1960 Corvette: Service Bulletin: Accelerator Pedal Falls Off Retaining Studs

Subject: Accelerator Pedal Falls Off Retaining Studs

Model and Year: 1960 Corvette Models

Date: June 15th, 1960

REWORK INSTRUCTION DRAWING TO COVER THE MODIFICATION OF
THE 1960 CORVETTE ACCELERATOR PEDAL # 3771749

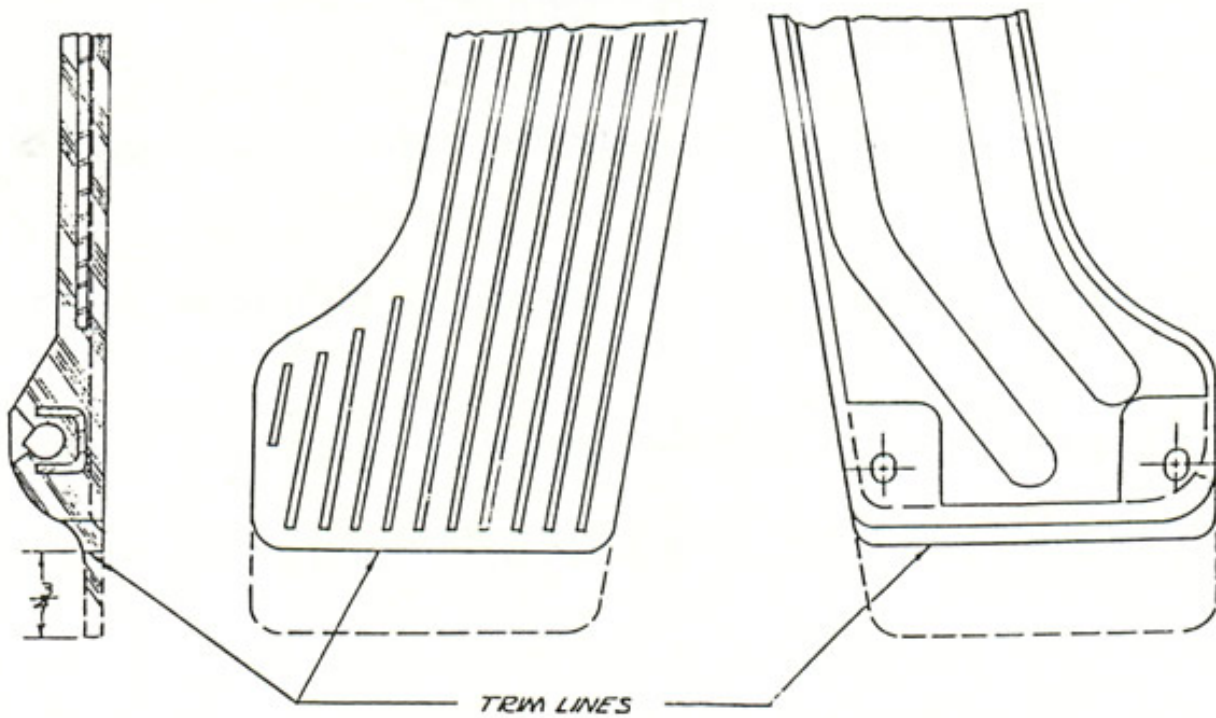
There has been a few complaints that the 1960 Corvette accelerator pedal snaps off of the two retaining studs at the heel end of the pedal, due to an interference condition between the floor mat material and the heel flap of the pedal.

As a Production correction, the assembly plant will revert to the 1959 design pedal, part #3760271, which does not incorporate the heel flap.
